**Responses to Public Comments  
Submitted on the Draft Regulatory Guide  
for Evaluation of Electromagnetic and  
Radio-Frequency Interference in Safety-  
Related I&C Systems  
(DG-1029)**

**September, 1998**

**U.S. NUCLEAR REGULATORY COMMISSION  
OFFICE OF NUCLEAR REGULATORY RESEARCH  
Division of Systems Technology  
Control, Instrumentation, and Human Factors Branch**

Figure 7 Comparison of low-frequency radiated emissions envelopes

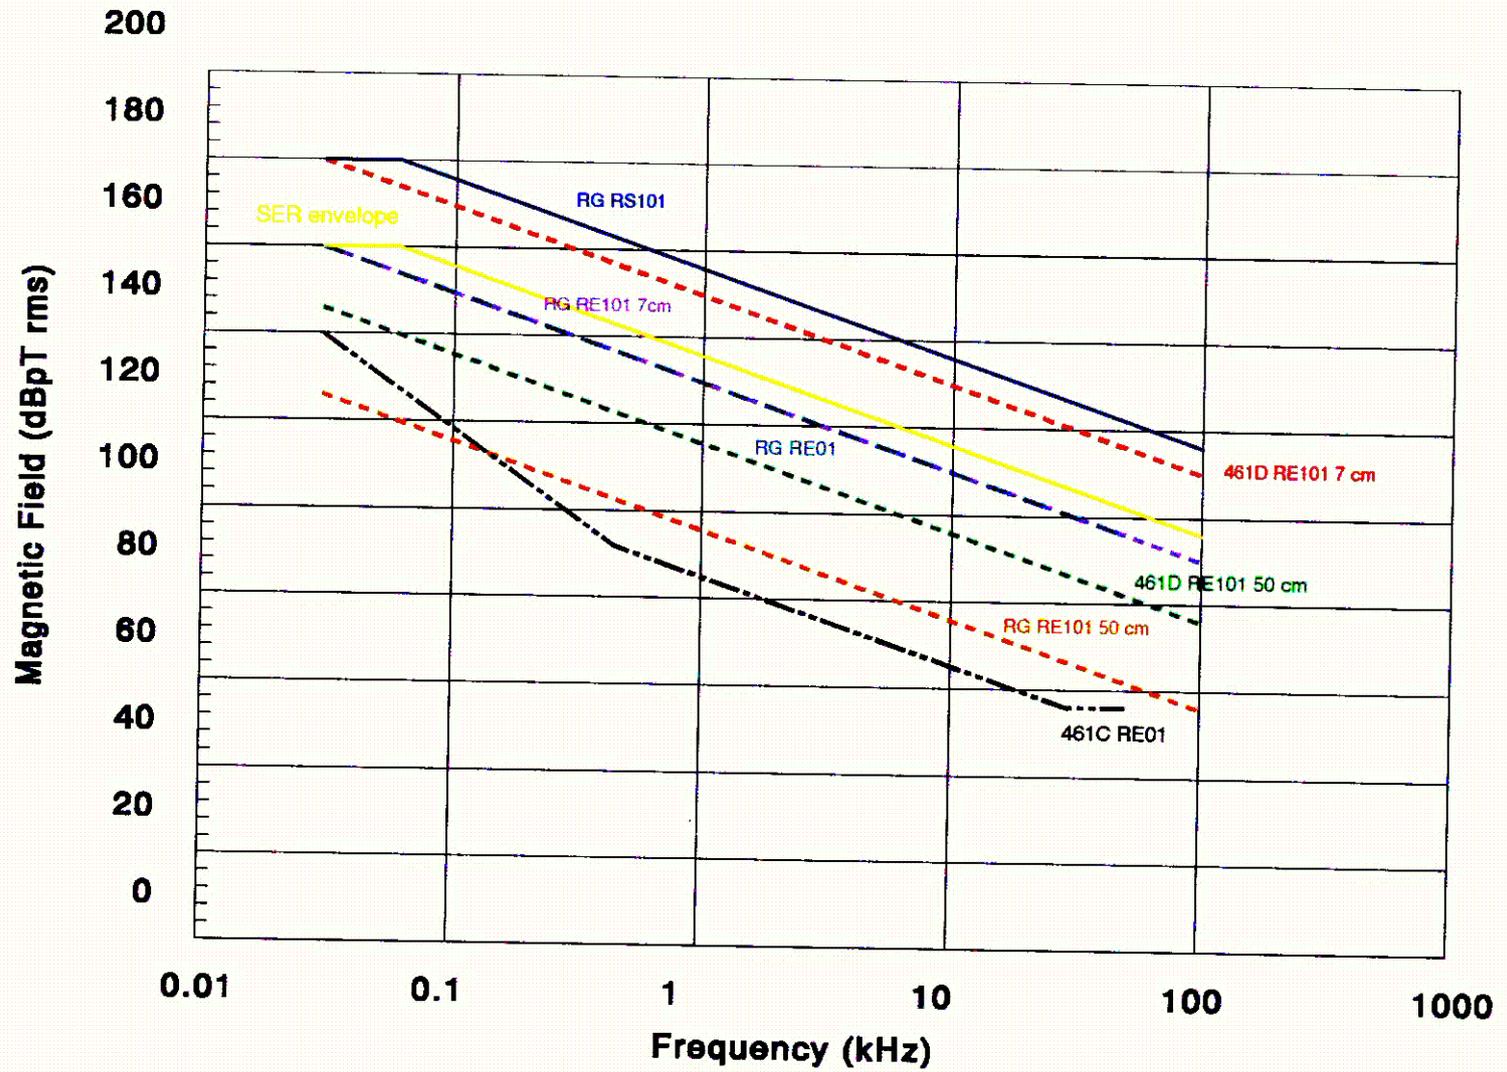
Figure 7 provides a comparative plot of the RG (i.e., DG-1029) envelopes for RE101, RE01, and RS101, the baseline MIL-STD envelopes, and the corresponding envelope endorsed by the SER on EPRI TR-102323. It is seen that the RG for emissions measured at a distance of 7 cm from the equipment and SER envelopes are similar in level. The RG envelope for emissions measured at a distance of 50 cm from the equipment provides an alternate envelope for area emissions control.

Figure 8 Comparison of high-frequency radiated emissions envelopes

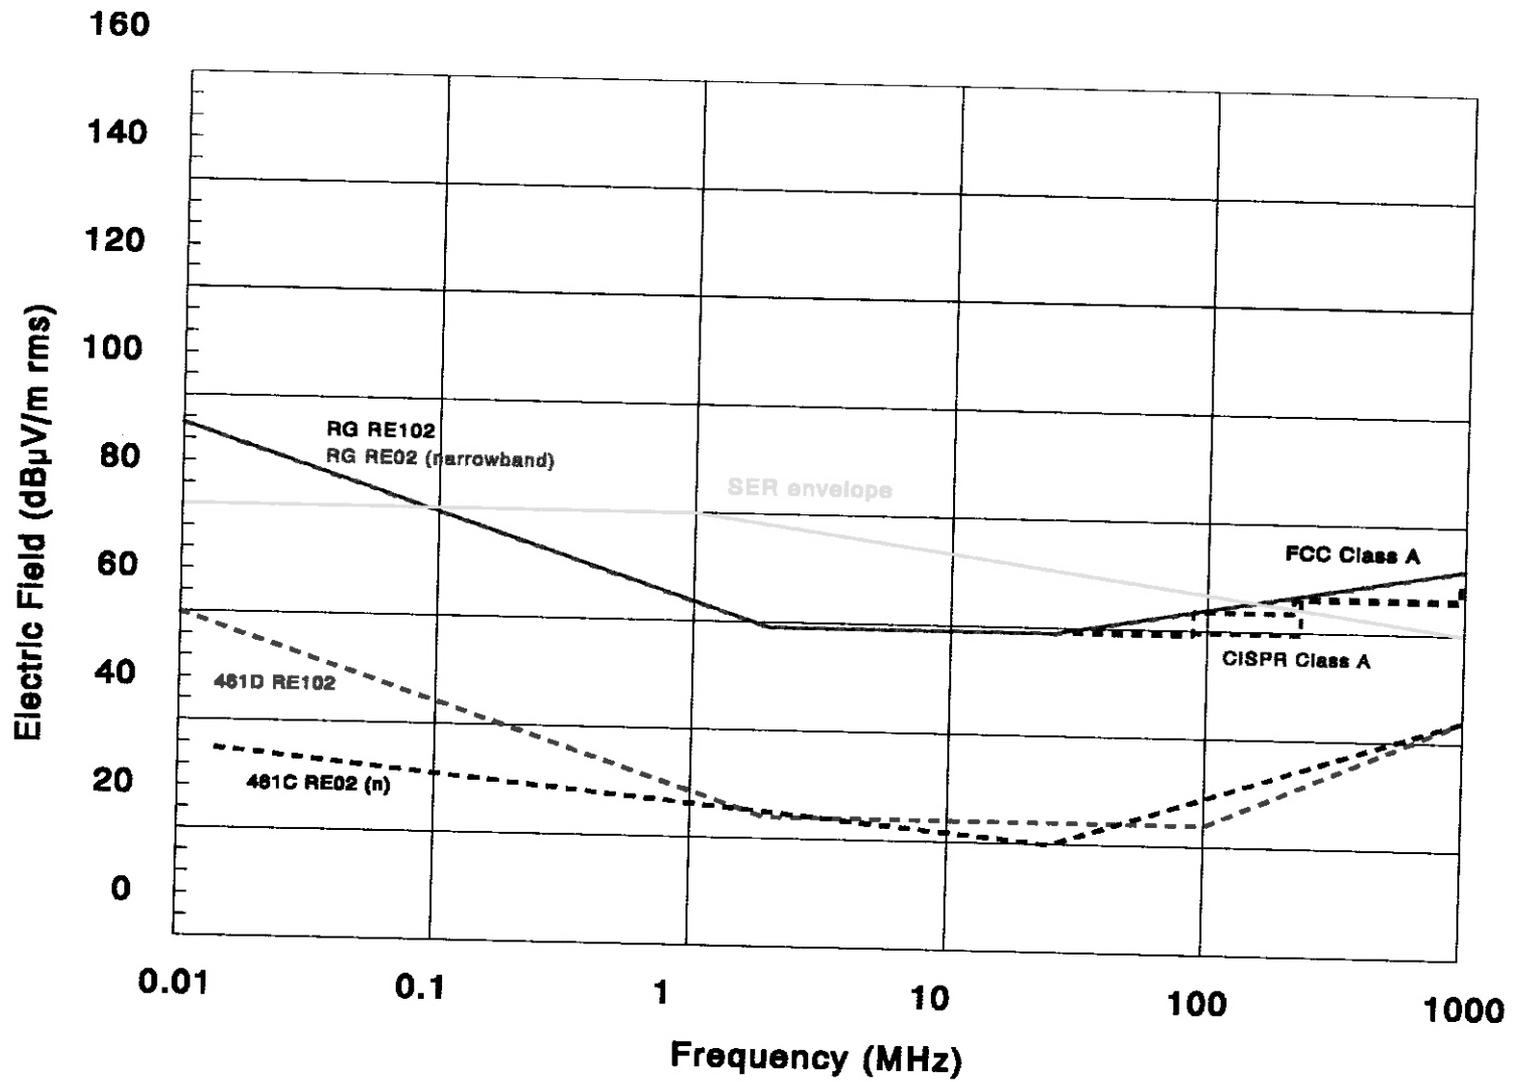
Figure 8 provides a comparative plot of the RG (i.e., DG-1029) envelopes for RE102 and RE02, the baseline MIL-STD envelopes, the corresponding envelope endorsed by the SER on EPRI TR-102323, and the Class A equipment emissions limits for CISPR and

Figure 4.1 CE101 Emissions Envelope for dc Power Leads

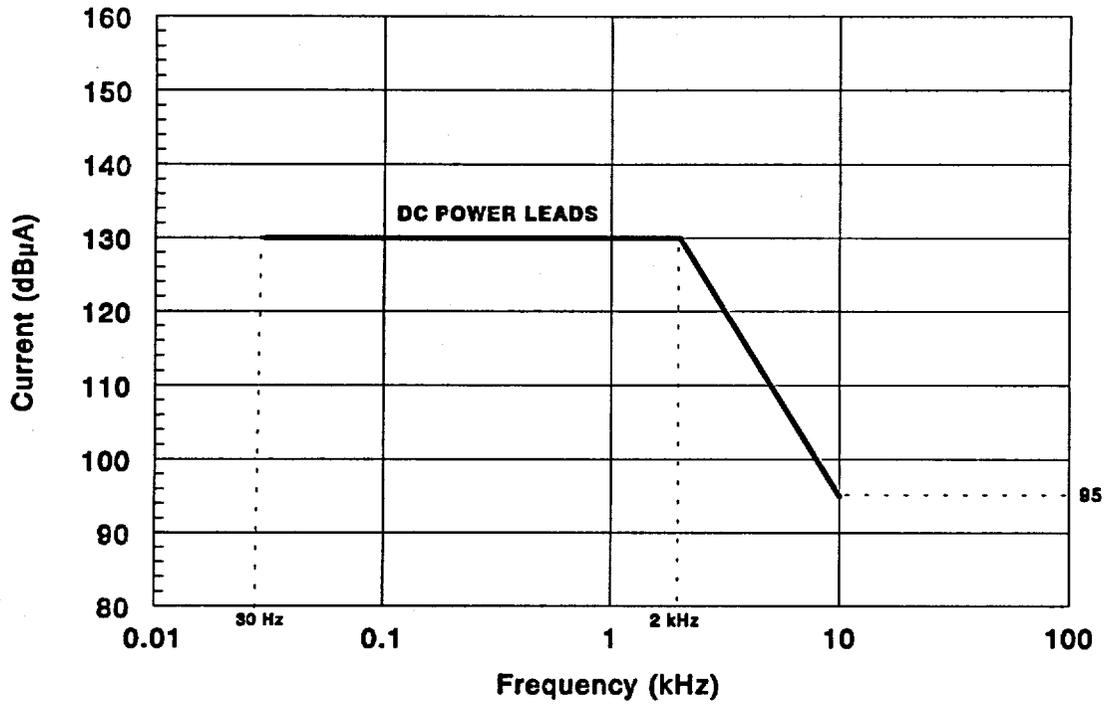
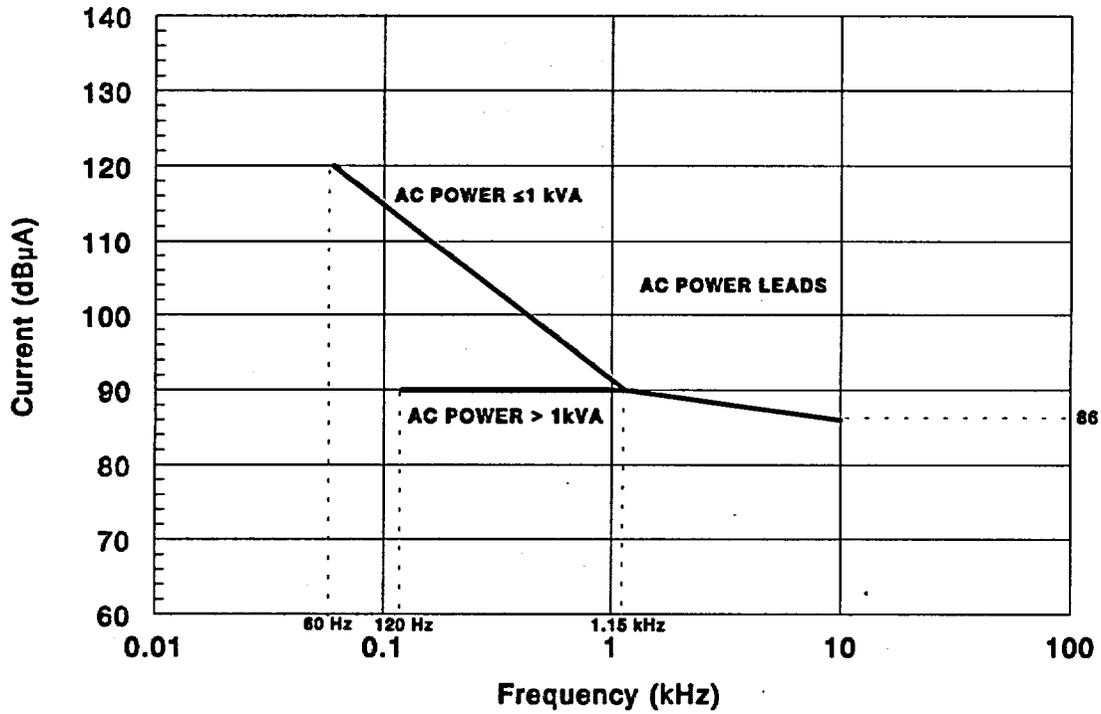
The limits set in Figure 4-1 are 32 dB $\mu$ A more restrictive than the TR-102323-R1 guidelines for the ac leads and 8 dB $\mu$ A less restrictive for the dc leads. Further, these levels are inconsistent with the guidance in MIL-STD 461D, which really only apply to Army and Navy aircraft and Navy ships and submarines. Further, Figure 4-1 does not give any guidance for variations due to consumption power level. The result is that a device drawing 500 milliamperes ac power (114 dB $\mu$ A at 60 Hz) could never pass this test. Suggest this paragraph and figure be revised to be more in line with the TR-102323-R1. <10>

via TR-102323 and the newly established limits from MIL-STD 461D. For an endorsement of MILSTD 461D emissions limits, Figure CE101-4 for source voltages above 28 V would be more appropriate and not compromise adequate safety margin. <49>

The emissions limit for AC Power Leads is excessively restrictive compared to other standards. No justification is provided for deviation from the less restrictive equipment emissions limits previously endorsed for low-frequency conducted equipment emissions, via EPRI TR-102323 and the newly established limits from MIL-STD 461D. For an endorsement of MIL-STD 461D emissions limits, Figure CE101-4 for source voltages above 28V would be more appropriate and not compromise the adequate safety margin.

The CE101 emission limits given in MIL-STD 461D are different than those shown in Figure 4.1. The values given in Figure 4.1 are based on the limits given in CE01 of 461C. An example of mixing two different sets of requirements-see statement in regulatory position C.3 that specifies no mixing and matching of test criteria. <106>

The figure illustrating the CE101 (conducted emissions, power leads, low frequency) operating envelopes will be replaced by two figures showing the operating envelope for dc power leads and the modified operating envelopes for ac power leads (see attached figures). Thus Figure 4.1 becomes Figures 4.1 and 4.2.

Figure 4.3 CE102 Emissions Envelopes

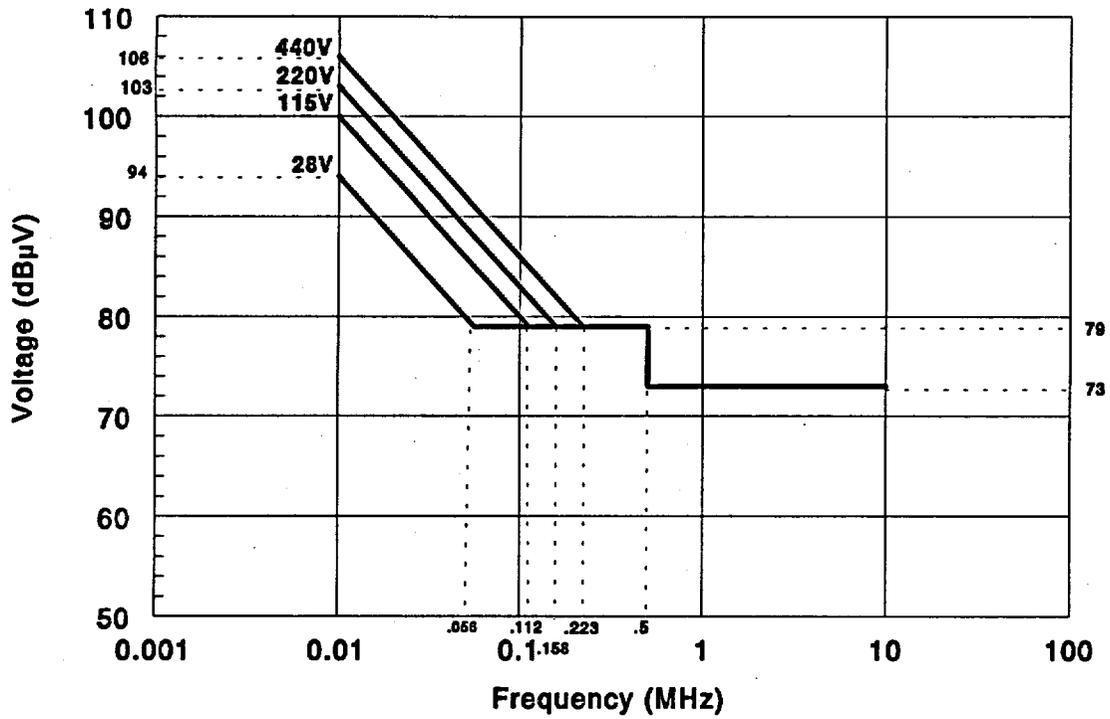
The limits in Figure 4.2 are extracted directly from MIL-STD 461D and are specified in terms of  $\text{dB}\mu\text{V}$  while all of the survey data in TR-102323-R1 and NUREG/CR-6431 was measured in terms of  $\text{dB}\mu\text{A}$ . If one takes the starting point for the 115V limit at 10 kHz ( $100 \text{ dB}\mu\text{V}$ ) and converts this to current on a 50 ohm line, this equates to  $66 \text{ dB}\mu\text{A}$  and this point is discontinuous (by  $21 \text{ dB}\mu\text{A}$ ) with the ending point from the limit for an ac line in paragraph 4.1. The uncertainty of actual line impedance at the point of measurement applies equally to both current and voltage measurement. However, the difficulty in making a voltage measurement was demonstrated in the site survey data by both EPRI and Oak Ridge. Clearly, voltage measurements are not practical and considerable site emission data exists in terms of current.

The figure illustrating the CE102 (conducted emissions, power leads, high frequency) operating envelopes will be replaced by a new figure showing the modified operating envelopes (see attached figure). Also, Figure 4.2 becomes Figure 4.3.

Figure 4.4 CS101 Operating Envelopes

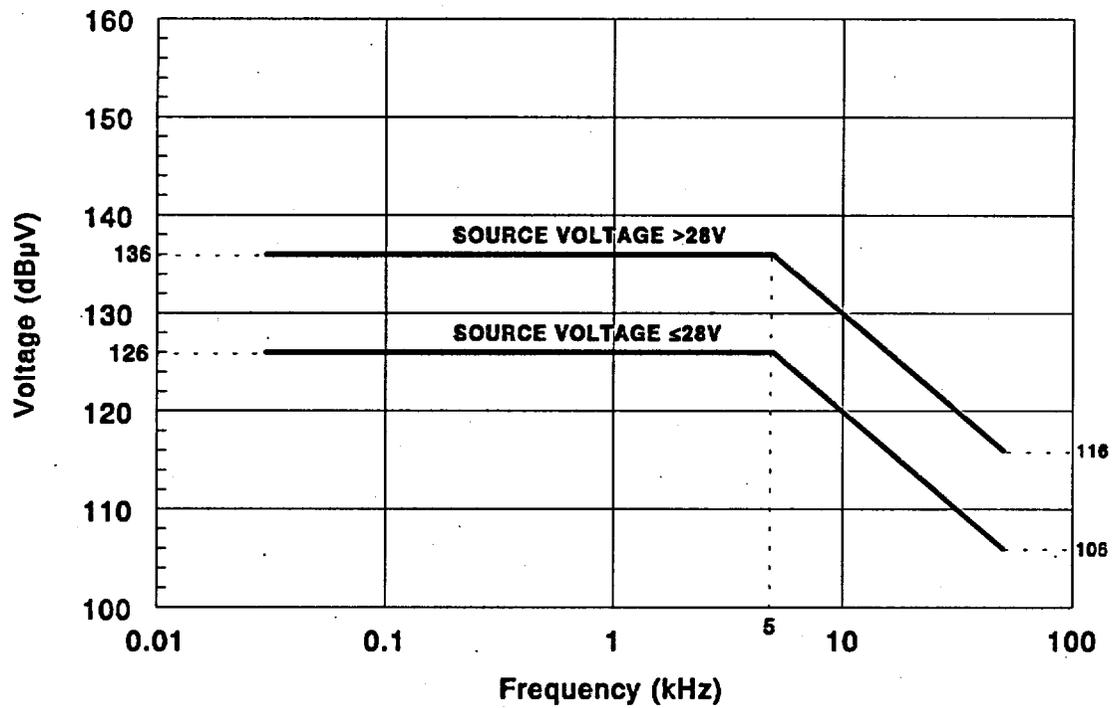
The end point shown in Figure 4.3 as 127 dB at approximately 50 kHz does not agree with the end point shown in Figure CS101-1 in 461D (116 dB at 50 kHz). <107>

The figure illustrating the CS101 (conducted susceptibility, power leads, low frequency) operating envelopes will be replaced by a new figure showing the modified operating envelopes (see attached figure). Also, Figure 4.3 becomes Figure 4.4.

Figure 4.6 RE101 Magnetic Field Emissions Envelopes

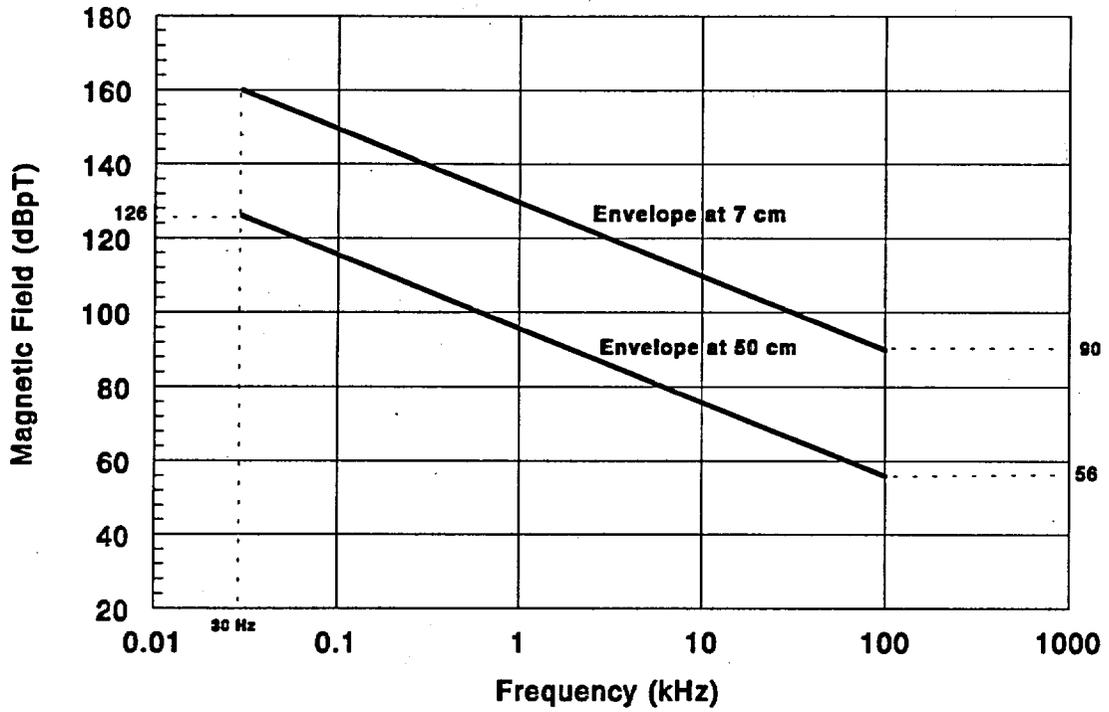
First, dealing only with the 7 cm envelopes, the curve from Figure 4.5 is 30 dBpT more restrictive than the curve from the MIL-STD 461D, Figure RE101-2 and 10 dBpT more restrictive than the limit from TR-102323-R1, Figure 7-3. A reasonable compromise would be to defer to the 7cm curve in Figure RE101-2 from the MIL-STD 461D. <15>

The suggestion here is to adopt the limit from Figure RE101-2, MIL-STD 461D for 7 cm and eliminate the limit for 50 cm. <16>

Figure 4.5 limits do not agree with RE101-1 or RE101-2 of 461D or Figure 6-13 (RE01) of 461C. <109>

<15> The emissions envelopes for radiated magnetic fields will be modified to correct an error in establishing the appropriate levels. The envelope given in Figure RE101-2 of MIL-

The figure illustrating the RE101 (radiated emissions, magnetic field, low frequency) operating envelopes will be replaced by a new figure showing the modified operating envelopes (see attached figure). Also, Figure 4.5 becomes Figure 4.6.

Figure 4.7 RE102 Emissions Envelope

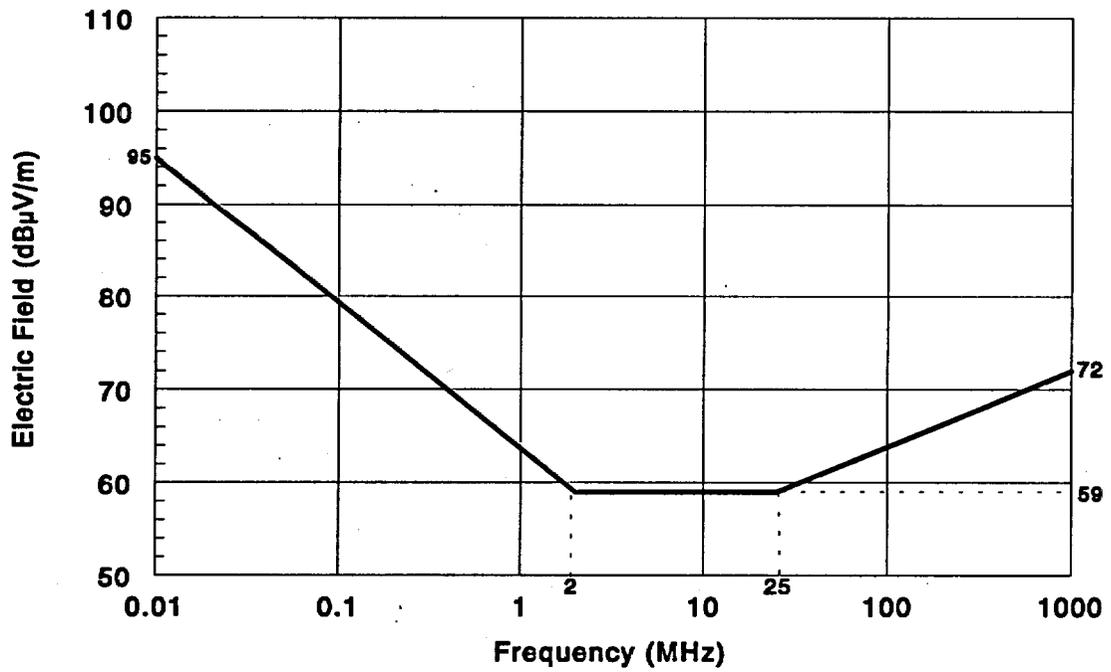
The emission limits in Figure 4.6 appear to be taken from MIL-STD 461D, RE102-2 and were meant to apply to aircraft and space system applications. At 1 MHz, these limits, at 24 dB $\mu$ V/m, are 50 dB $\mu$ V/m more restrictive than the limits in TR-102323-R1, Figure 7-4. The survey data reported in NUREG/CR-6431, Table 6.2, indicate the highest observations are in excess of 107 dB $\mu$ V/m. The TR-102323-R1 closely matches the FCC Part 18 Industrial Scientific and Medical Emission guidelines. The Figure 4.6 emission limits do not appear to be based on either the ORNL experience or the EPRI experience and would result in unreasonable requirements for equipment manufacturers.

The original RE102 operating envelope presented in DG-1029 was based on Fig. RE102-3 in MIL-STD 461D. The envelope for Army ground applications was selected. The envelope was extended below 2 MHz to provide complete coverage of the frequency range corresponding to the test method. The basis for the envelope from 10 kHz to 2 MHz is a relationship with CE102 (conducted emissions, power leads, high frequency), which addresses power quality issues [MIL-STD 461D App., p. A-25]. Thus, the emissions envelope was continuous over the frequency range corresponding to the test criteria in DG-1029 and provided consistent coverage compared to RE02 (radiated emissions, electric field, high frequency). Use of the restrictive Army emissions envelope was justified because the site survey data for electric fields, reported in NUREG/CR-6436, closely approach the 8 dB margin band below the RS103 (radiated susceptibility, electric field, high frequency) operating envelope. Therefore, close control of radiated electric field emissions seemed justified.

The figure illustrating the RE102 (radiated emissions, electric field, high frequency) operating envelopes will be replaced by a new figure showing the modified operating envelopes (see attached figure). Also, Figure 4.6 becomes Figure 4.7.
